Title:	Firmware update for GP58-CR		
Model:	GP58-CR		
Control Number:	F AE_2022010701	Date:	2022/01/07

Technical announcement:

- I) Firmware version label is under the transparent cover
- II) Firmware version read out by GP58-CR PC tool

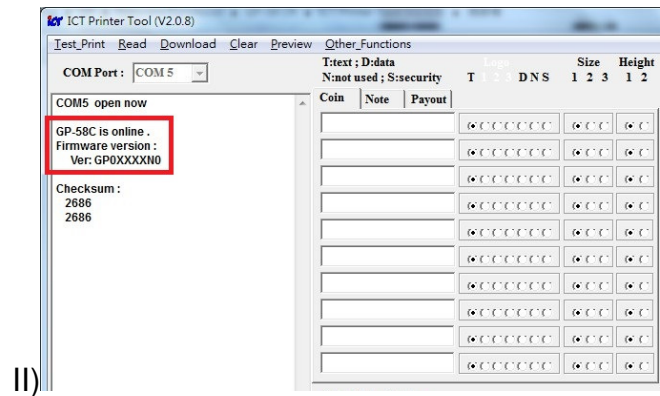
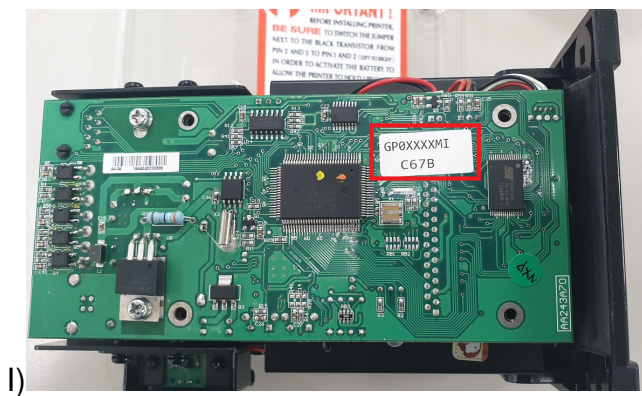
- 1) In order to prevent GP58-CR date/setting issue, firmware version before (includes) **“GP0XXXXMQ(98DA)”** must update it to the latest firmware version **“GP0XXXXN0(2686)”**.
(Please contact ICT local distributors/branches to get the latest firmware & GP58-CR PC tool.)

***The firmware label is showing on CPU board which located in the bottom of GP58-CR, or use GP58-CR PC tool to read out the unit firmware. If your GP-58CR is already experiencing a date/time issue, please perform firmware and tool update using the latest version, regardless of your installed version.

- 2) After firmware updated, please use the latest GP58-CR PC tool (as link as below) to check and set again the format layout & other relative settings into GP58-CR, to ensure the settings are correct.
